California Energy Commission
Computers, Computer Monitors, and Signage
Displays Appliance Efficiency Rulemaking

ITI/TechNet Oral Comments on the Rulemaking

Docket No. 16-AAER-02

October 10, 2016

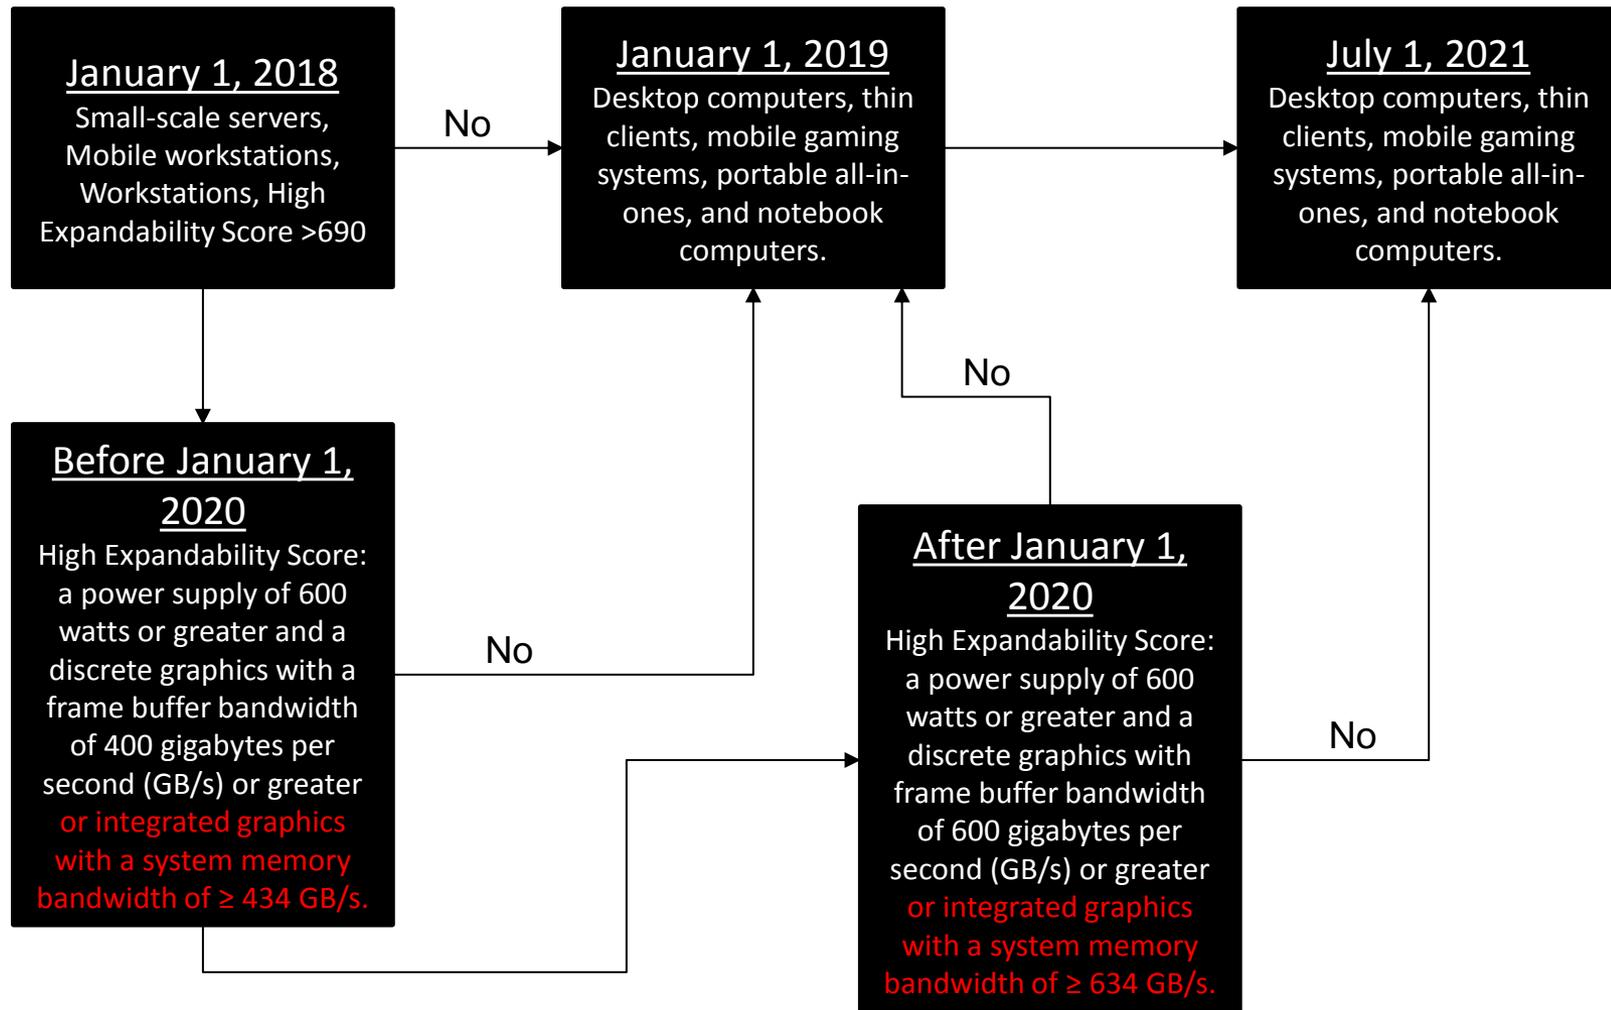
- Mode weightings:
 - 1604 (v)(5)(B) allows for Conventional and Full Capability Duty Cycles
 - ITI has confirmed that not all OS and hardware suppliers support the Full Capability requirements.

- Three major non-proprietary operating system manufacturers do not support Full Capability
 - Two of three of the major network interface chip manufacturers do not support Full Capability

- OS and hardware suppliers do support the “remote wake” capability
 - Proposed change would insure all computer manufacturers would have the option of choosing between either Conventional or Remote Wake duty cycle weightings

- Mode weightings (Cont'd) - Industry proposes modifying 1604 (v)(5)(B) as follows:
 1. Modify last sentence, '... unless they meet the criteria to use ~~“full capability”~~ “remote wake” mode weightings, below.'

2. In order to use the ~~“full capability”~~ “remote wake” mode weighting a computer shall have the following features enabled as shipped:
 - i. Maintain Ethernet (*IEEE 802.3-2015*) or wireless (*IEEE 802.11-2012*) network addresses and network connection capability while in ACPI System Level S3 Sleep Mode or an alternative to ACPI S3 sleep mode; and

- ii. ~~Resume from ACPI System Level S3 Sleep Mode or an alternative to ACPI S3 sleep mode upon request from outside the local network~~ While in ACPI System Level S3 Sleep Mode or an alternative to ACPI S3 sleep, the system is capable of remotely waking upon request from outside the local network.

- iii. ~~Support advertising host services and network name while in ACPI System Level S3 Sleep Mode or an alternative to ACPI S3 sleep mode.~~

Current Effective Dates

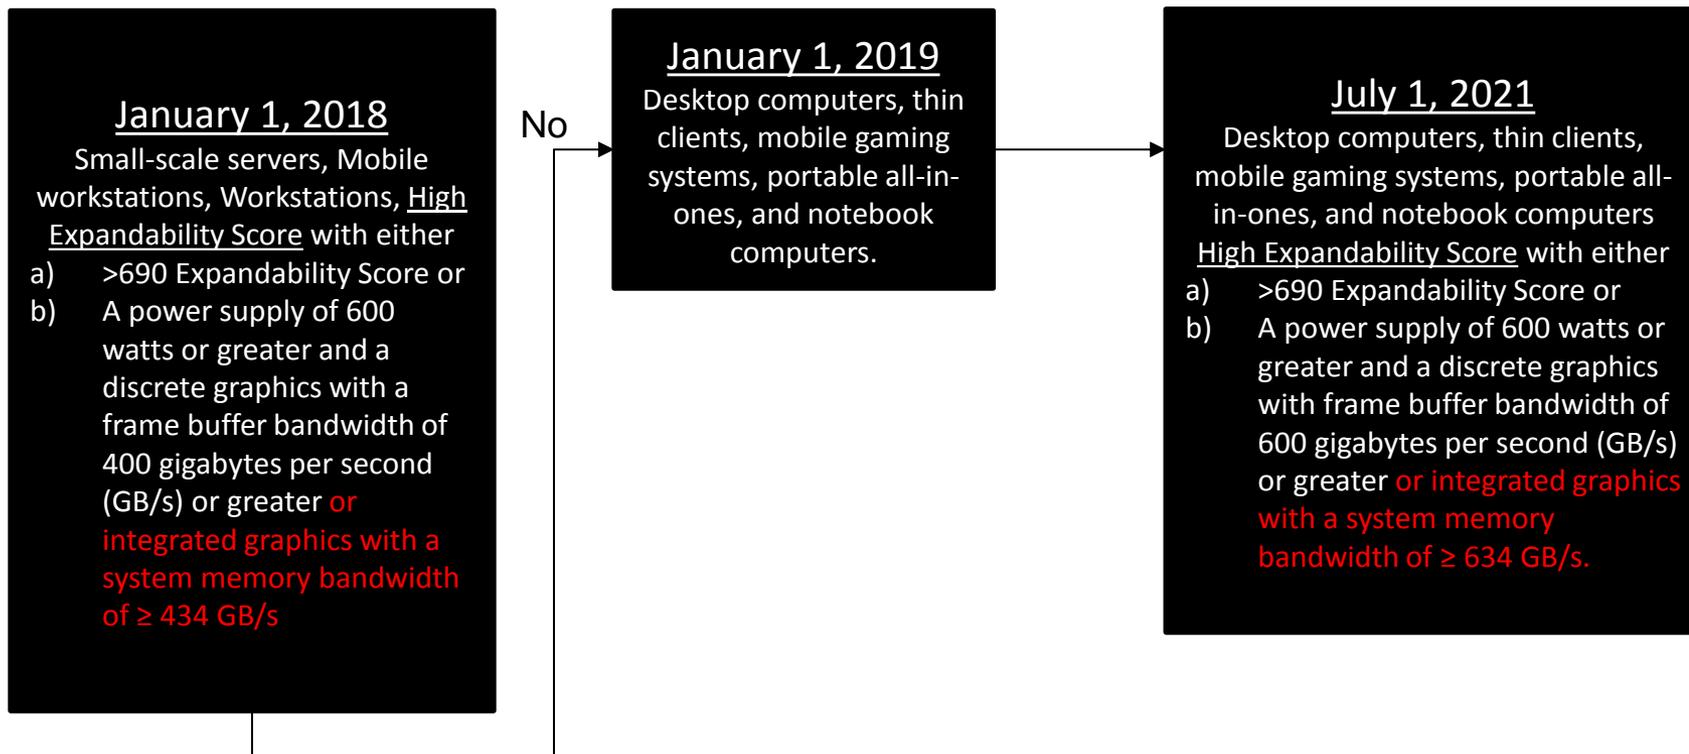
- **High expandability computer**
 - Compliance for computers meeting the high expandability criteria (per definition) start January 1, 2018. However the dates for discrete graphics and power supply requirements are on a different timeline (“before January 1, 2020” and “on or after January 1, 2020”). It is confusing and unnecessary to track these dates. This could inadvertently lead to potential non-compliance.

- Industry Proposal: Modify High expandability computer criteria (2) to remove the following language “If the computer is manufactured before January 1, 2020”, and modify (3) to change from “on or after Jan 1, 2020” to “on or after July 1, 2021” to align with computer Tier 2 dates. (see visual slides)
